Invitation for Bid No. 2025-006

Union County Sheriff's Office Fuel Station

ADDENDUM No. 2

SHERIFF'S OFFICE FUEL STATION
MONROE, NC
Consultant Project No: 2241794

1 SITE-ELECTRICAL PLAN
1" = 40'-0"

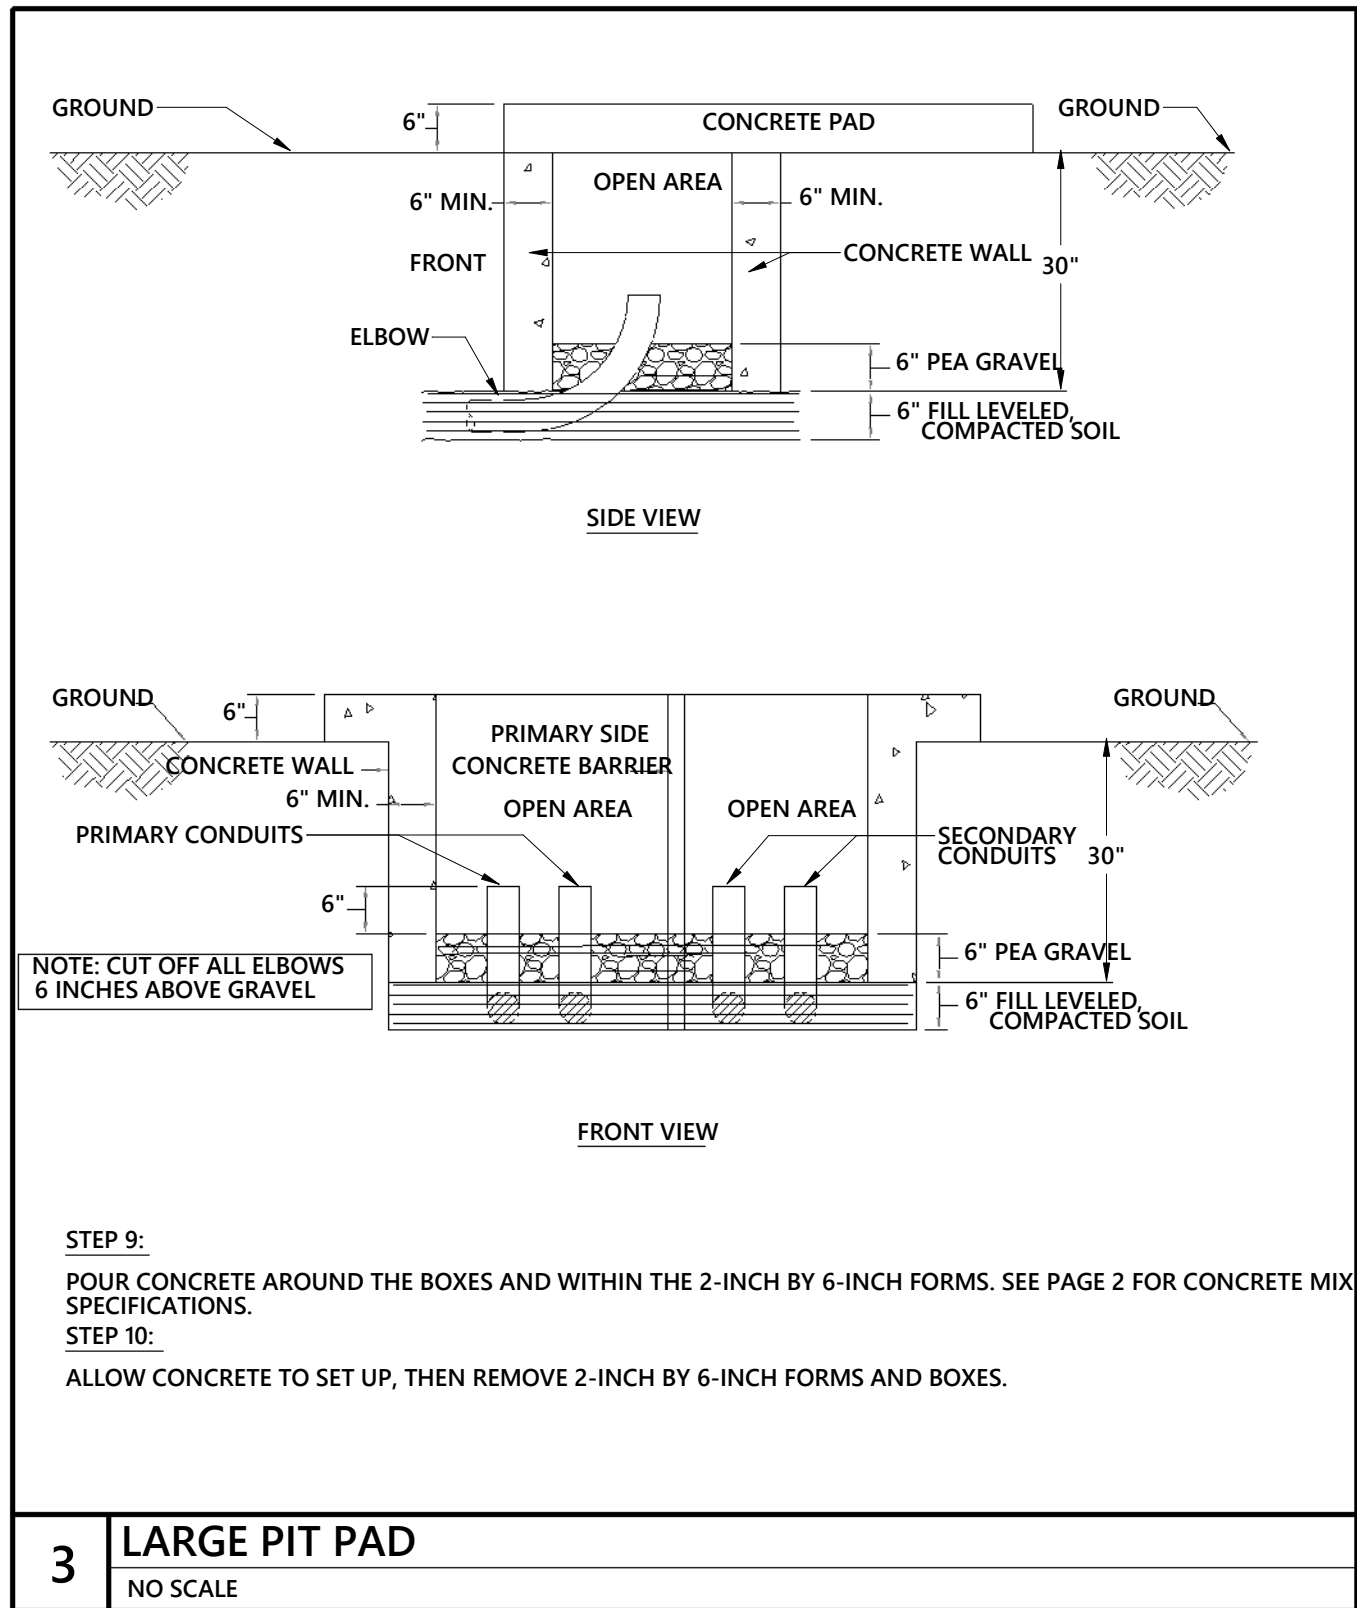
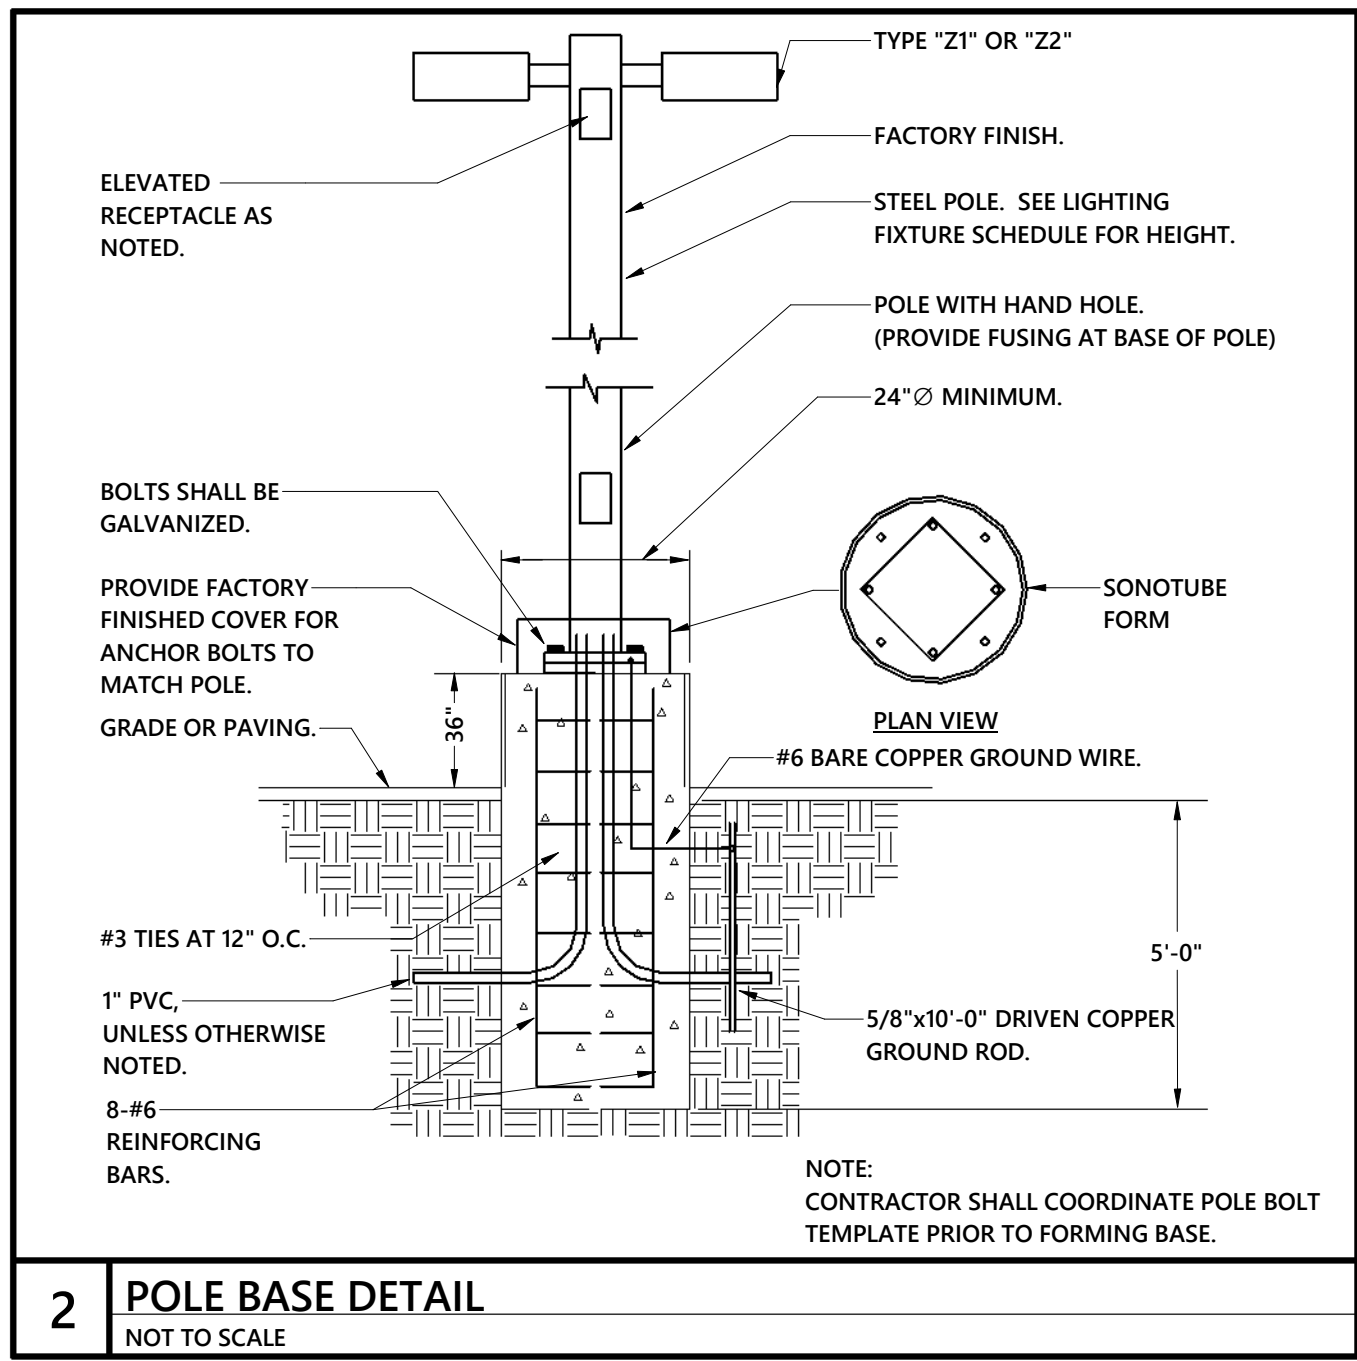
- a. If not, please provide updated drawing for concrete and privacy wall for estimating
7. Please send drawing of anticipated interior conduit path with anticipated linear footage as discussed at prebid.

12. Per review of the above plan sheet (G001). Per note Project Scope shown on the plan sheet noted above. Last item on scope list states to provide security camera for area surveillance. No specifications have been provided for this security camera. Will this be provided direct by Owner? Will we only need to provide conduit with pull string for final installation to be complete by Owner? Provide security plan sheet showing where conduits from new camera will need to be installed from starting point to final connection point.

7. Interior conduit routing plan attached for reference.
8. Extension of the bid date issued as Addendum 1,
9. Yes, lifts are acceptable to use.
10. Fuel resistant caulking added to detail on sheet A101.

12. Cameras provided by owner. Conduit and cabling provided by contractor from main electrical room to fiber cable box on fuel station enclosure. Contractor to provide conduit with pull string from cable box to fuel dispenser and camera locations. Interior conduit routing plan attached for reference.

A101

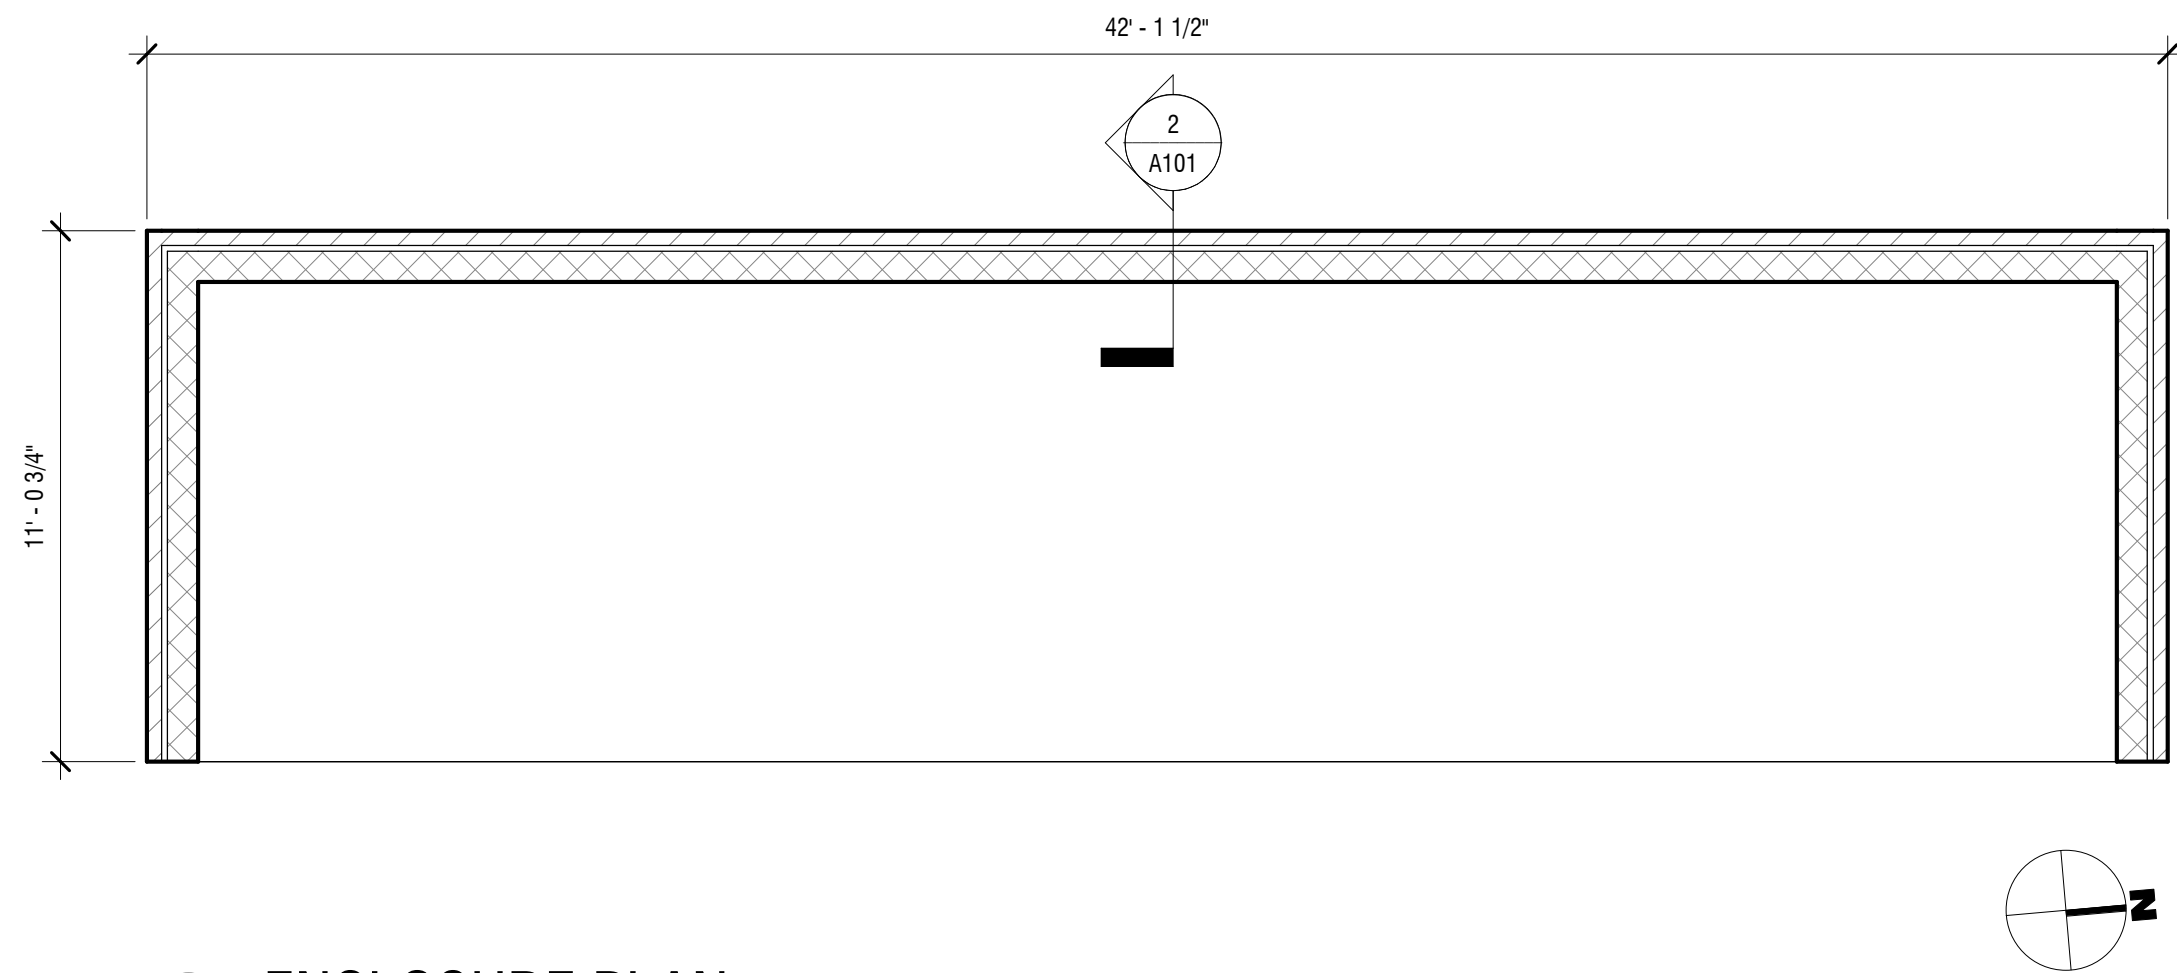
10. Per review of the above plan sheet. No Fuel resistant caulking as been shown to be installed around top of expansion joint materials around the bottom of the new concrete slab where it butts up to new CMU walls. Review this issue and confirm if this will be required.

13. Per review of the above plan sheet (A101). Please provide specifications on the existing brick that was used for the new Sheriff's office so correct masonry materials can be priced to match existing brick materials.

13. Brick: Palmetto Brick - Chocolate Wirecut; Mortar: Holcim Type N
